CABLE TERMINATIONS

BSURE TERMINAL AND TRANSMISSION UNITS

DESIGN REVIEW TEAM REPORT

COMPILED BY CHESAPEAKE DIVISION,

1) CHECK EFFECT OF PIECE #27 BEING BACKED - OUT AS A RESOURT OF THE POTENTIAL PROBLEM FROM PRECESSING PARAGRAPH.

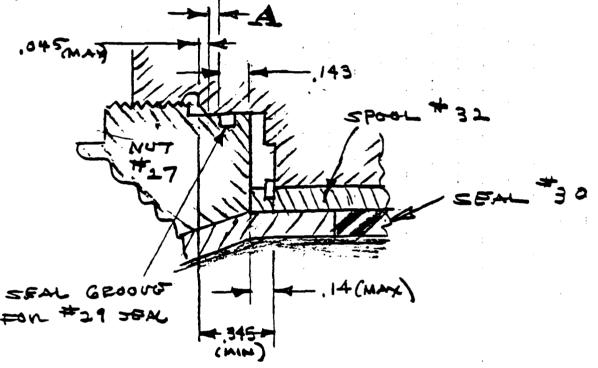
CLEARANCE A BETWEEN 0-RING GROOVE AND BOSE, WITH SPOOL #32 BOTTOMED ON NUT #27:

SEAL 26 CONTO

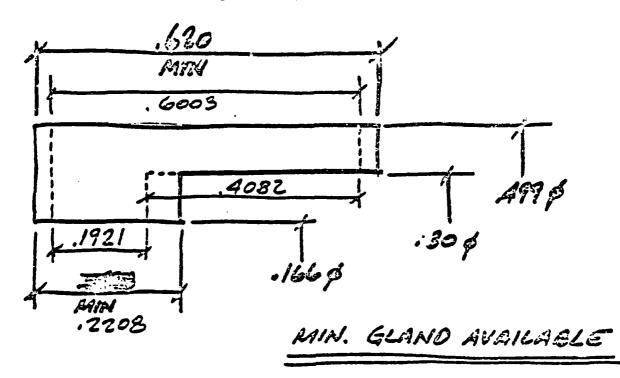
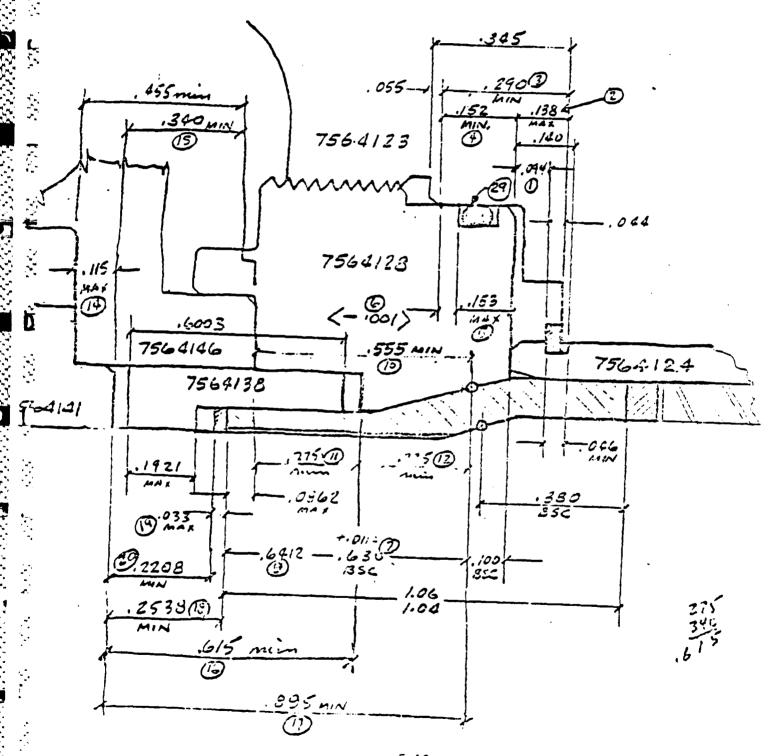
- b. Morrison-Type Seal Number 26 Installation: This seal will not exceed the available volume in the seal cavity. However, there is a seal back up ring drawing number 7564009 which appears to fit this cavity, although this is not clear from the drawing. If indeed it is installed with seal number 26, their combined volume will exceed the available volume by 3%. This will cause gapping between piece number 25 and 27. While this will not present a seal problem, it will have the effect of backing piece number 17 out of the termination housing, piece number 9. This is undesirable, so measurements should be taken at assembly to ascertain that the gap does not exist. If it does, the length of seal number 26 should be reduced, or possibly leave out the seal back-up ring.

- 1.3.1 CHESDIV page 9: The wrong backup seal ring was used in this analysis.
- 1.3.2 Delco page 2: Shows adequate gland volume for the seal. No change to be made.
